Raymond Jean

Objection to NY34.27: 15 - 25 Poyntz Avenue - Official Plan Amendment and Zoning By-law Amendment Applications - Decision Report – Approval

Proposed Site Plan for 15-25 Poyntz Ave (Application Number:25252382NNY18SA):

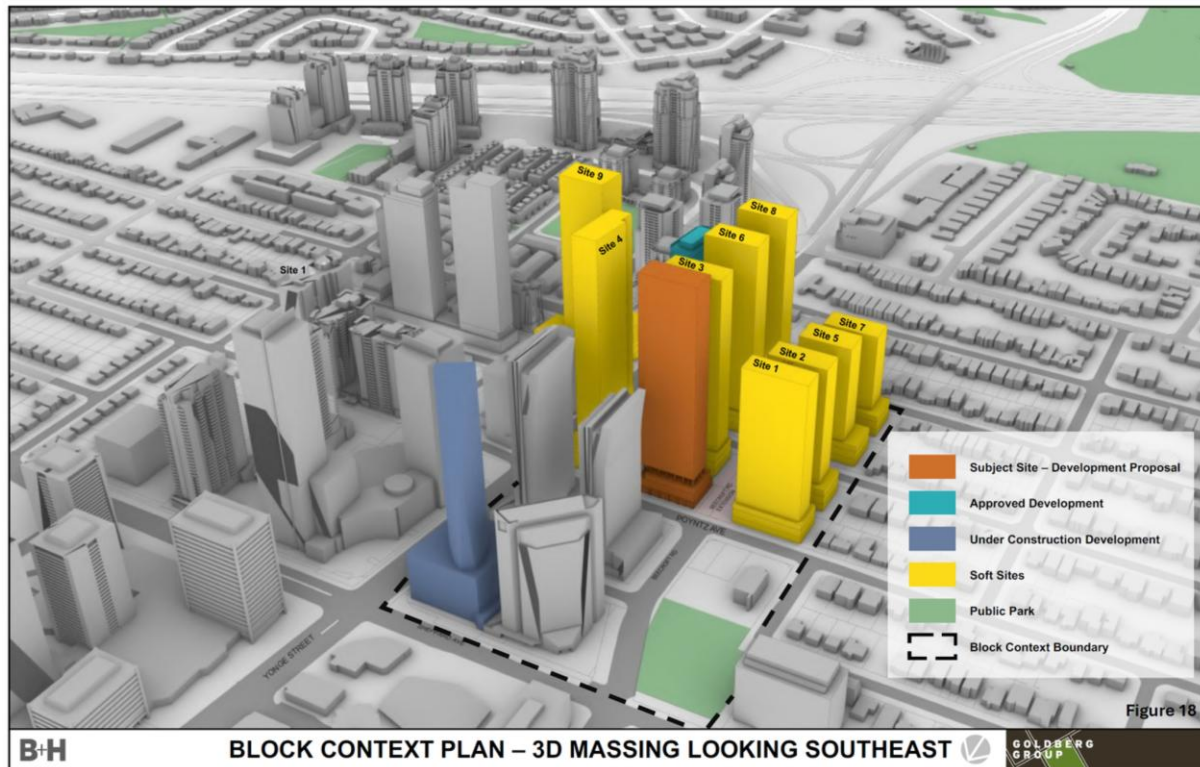
Where's the Park? Park between base of Subject Site & Site 4 – if you can't find it, how will the Sun?

Block Context Plan:

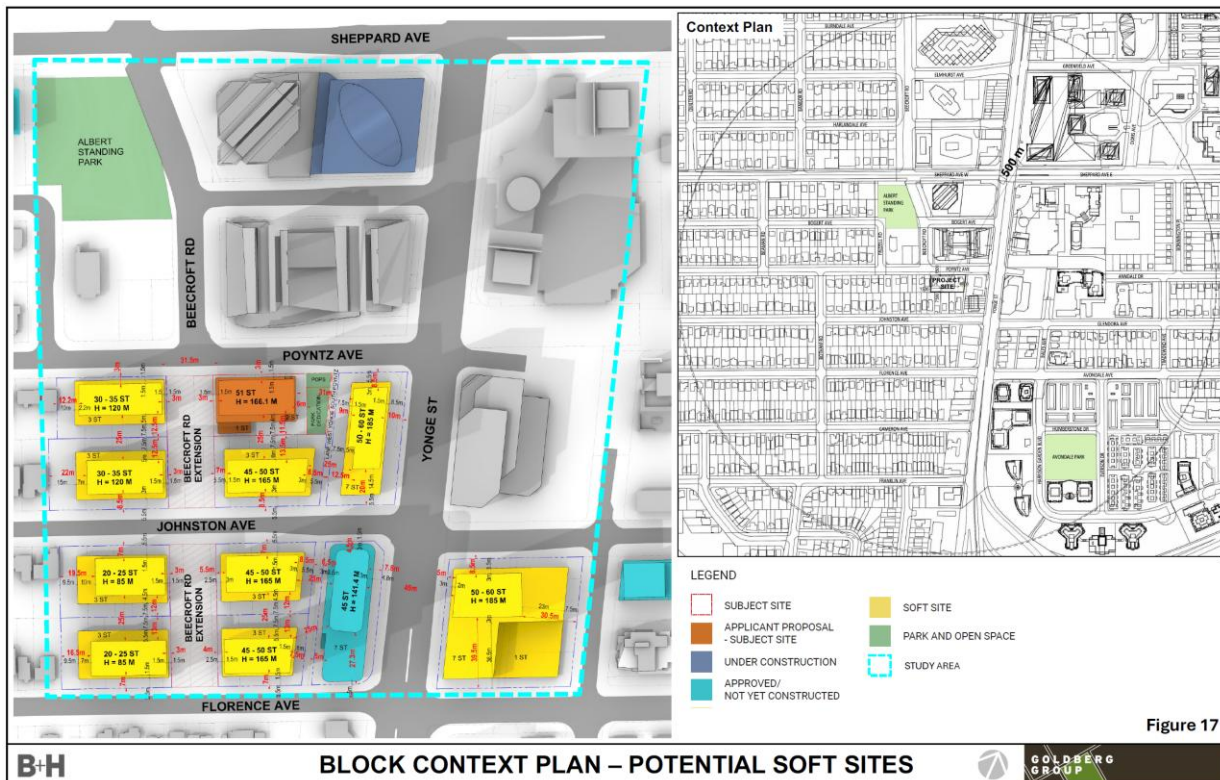
Proposed 1-lot Park & POPS (Privately Owned Public Space) will be surrounded by 40, 45, 50+storey buildings – park will not be Green! Park will never see the light of day!

Red Line show Subject Site Building not align with existing & proposed buildings – not enough setback on proposed Beecroft – **would block/limit design features for Beecroft South Extension! Road widening? dedicated turning lanes? on-street parking? continue linear park – switch sides? “Complete Streets” bike lanes? etc,...**

- Relocate Parkland Dedication & POPS to west-side of site along Beecroft South Extension where there will always be more sunlight!
- Relocate building eastward closer to Yonge – further from Albert Standing Park & Church to minimize shadowing

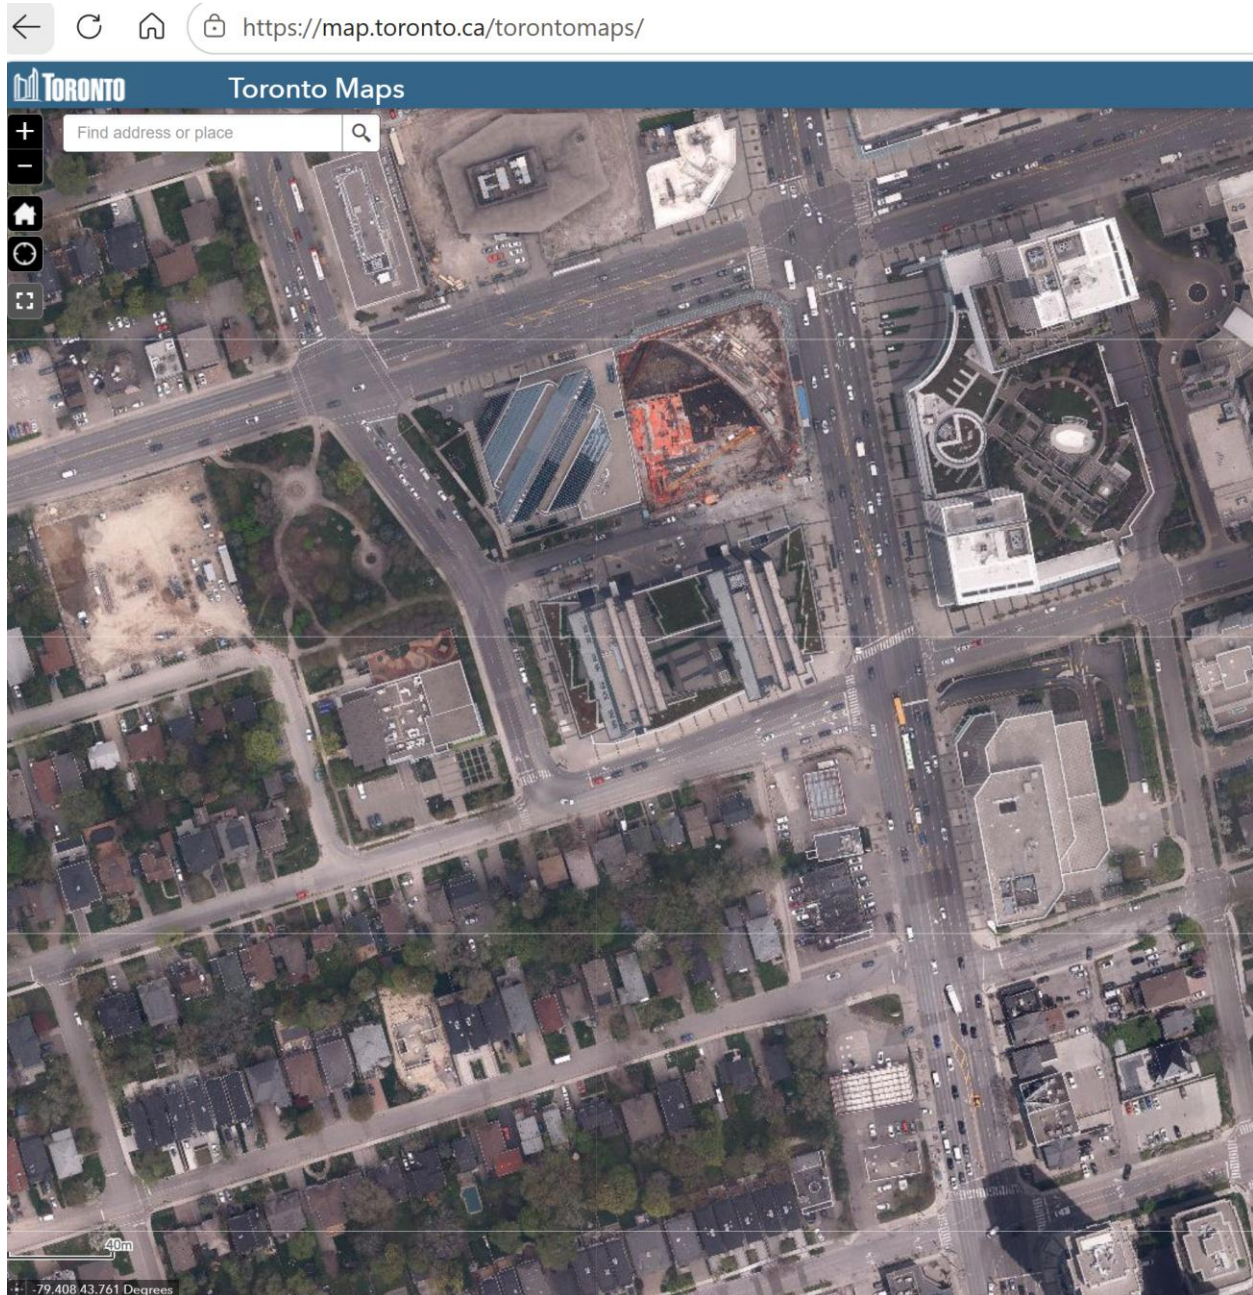
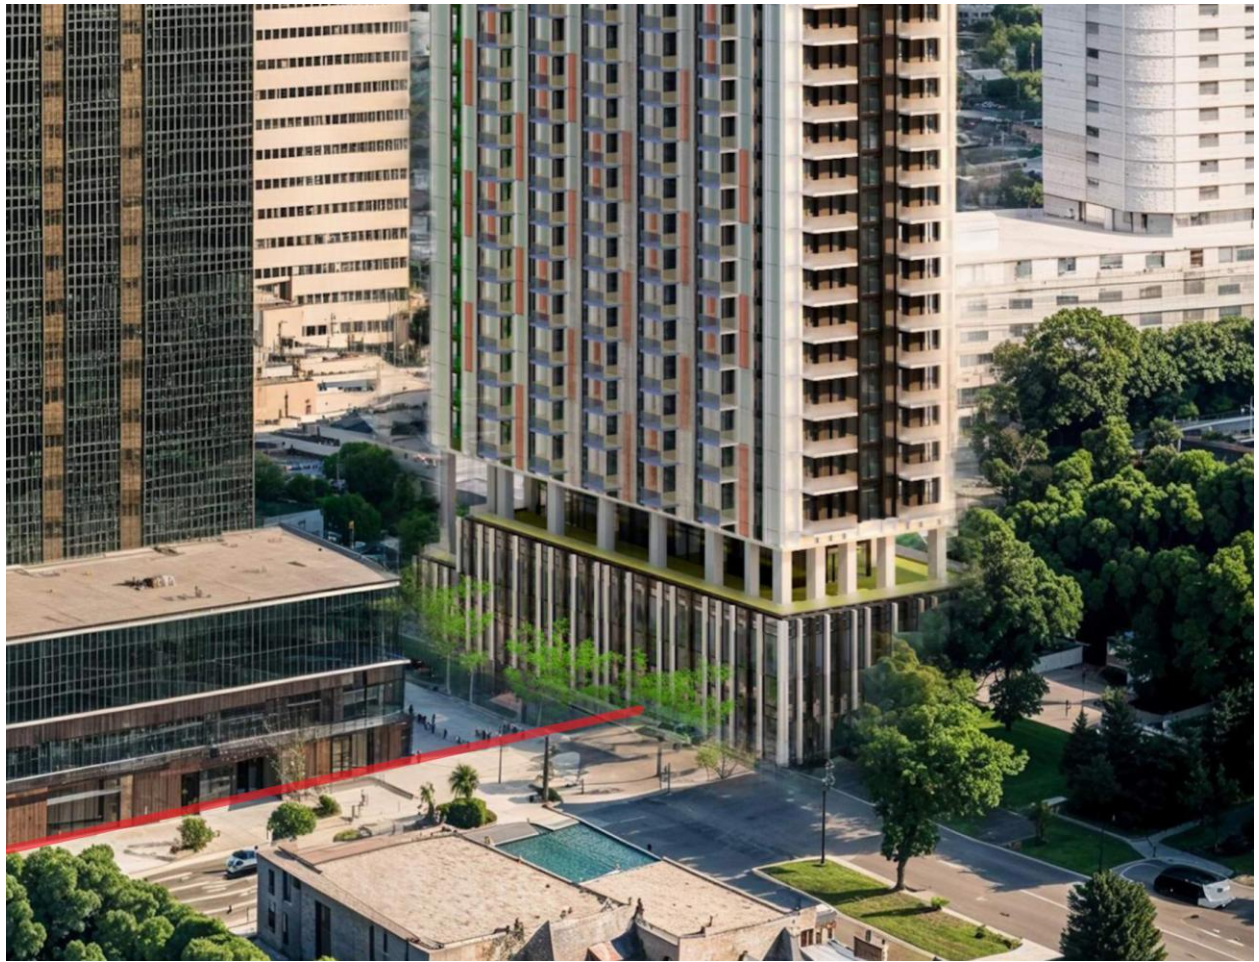
Aerial Photo shows: “Linear Park/GreenSpace” boulevard along east side of Beecroft north of Poyntz Ave to Sheppard – this is City Property, **good for road widening, dedicated turning lanes, on-street parking, continue linear park – switch sides? “Complete Streets” bike lanes, etc,....** Should be subject to **Community Consultation this Fall!**

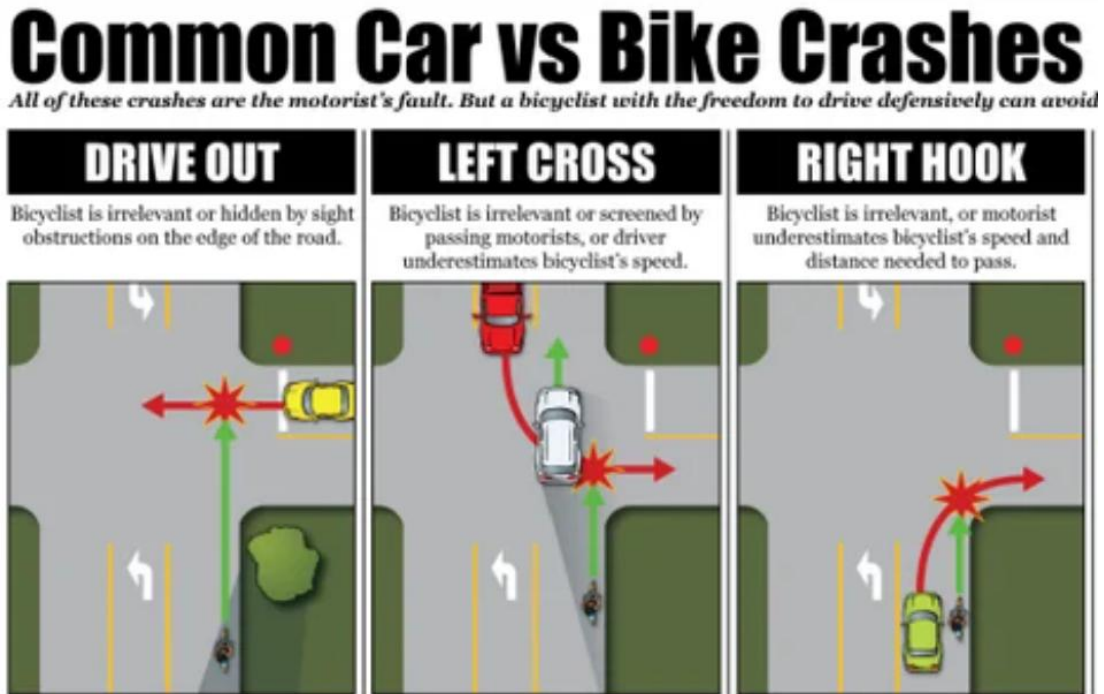
Road Grid system favour east-west side-streets, of which about 20 between Sheppard & Finch:

- **Intersecting Yonge St every 80m – creating numerous dangerous Cyclist-Vehicle Conflict Points in close proximity**

- 90% of these east-west side-streets dead-end or loop-out before intersecting with west-side of Beecroft & east-side of Doris,... designed to limit traffic infiltration from high-density Yonge corridor into Single Residential House area. **Side Effect: west-side of Beecroft & east-side of Doris has long continuous sidewalk of 500, 550, 650 & 850m length – perfect for safe cycling infrastructure – namely bi-directional multi-use trails.**

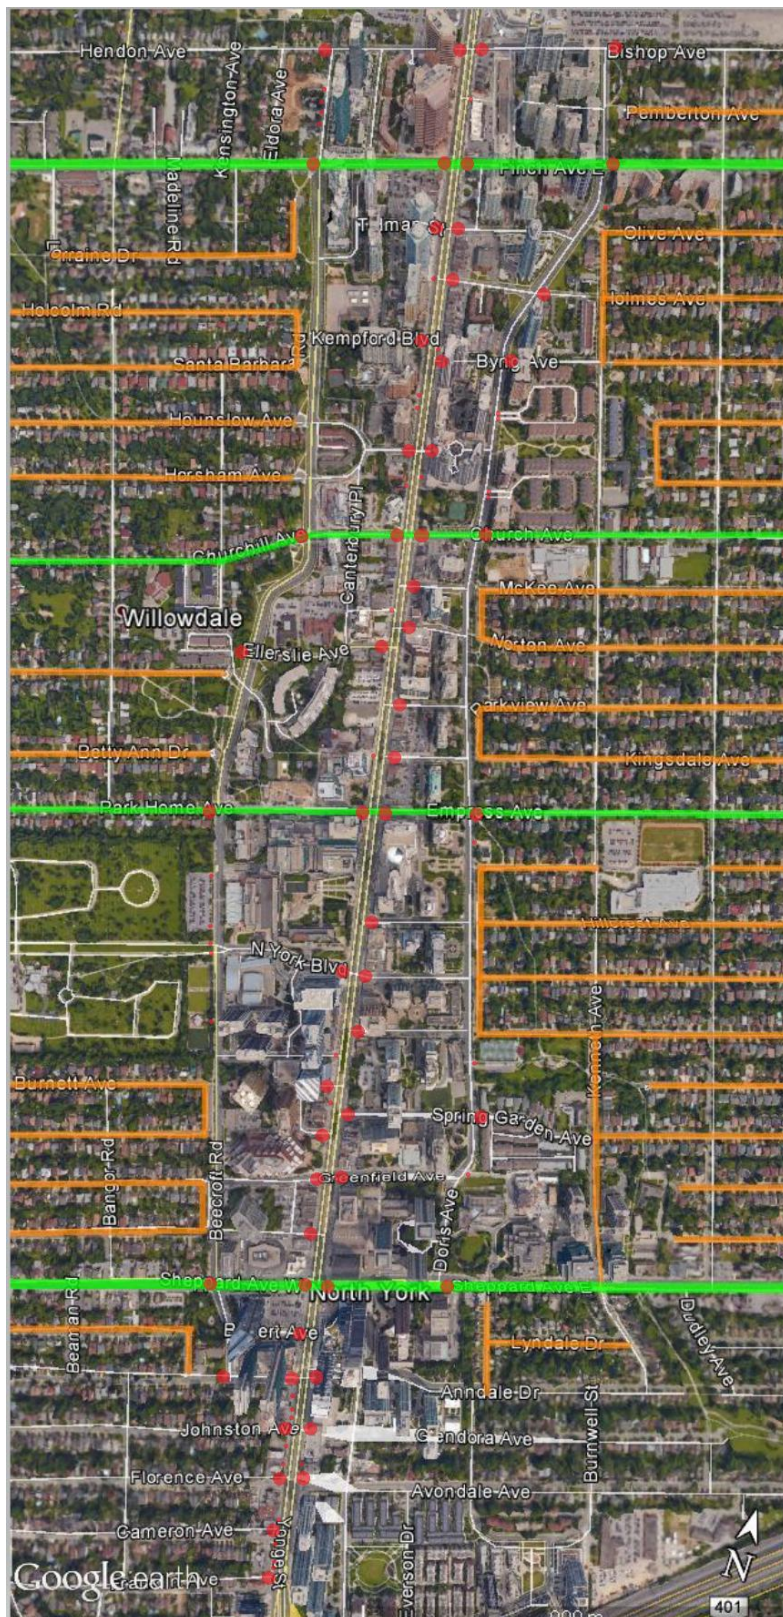
Major Cyclist-Vehicle Conflict Points: between Sheppard to Finch,... 26 on Yonge VS 3 on Beecroft west-side VS 5 on Doris east-side. Therefore Yonge St is 10 times more dangerous than Beecroft west-side,... factor in higher traffic volume: **bike lanes on Yonge is 100 times more dangerous than Beecroft west-side & about 50 times more dangerous than Doris east-side**

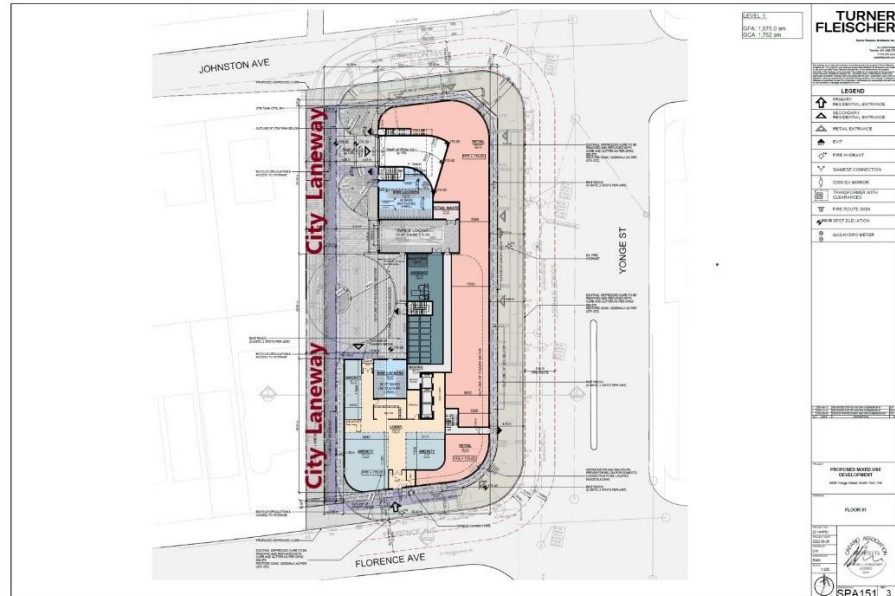
Problem: Proposed Condo Driveway parallel to existing City Laneway 40 feet away is redundant waste of space!

Solution: Relocate the Condo portion eastward adjacent to existing City Laneway and use it as Condo Driveway since any Re-Development of nearby Shell Gas Station (4722 Yonge St) will likely use this City Laneway as their Condo Driveway as well,.... as per approved 4696 Yonge & proposed 11-21 Johnston
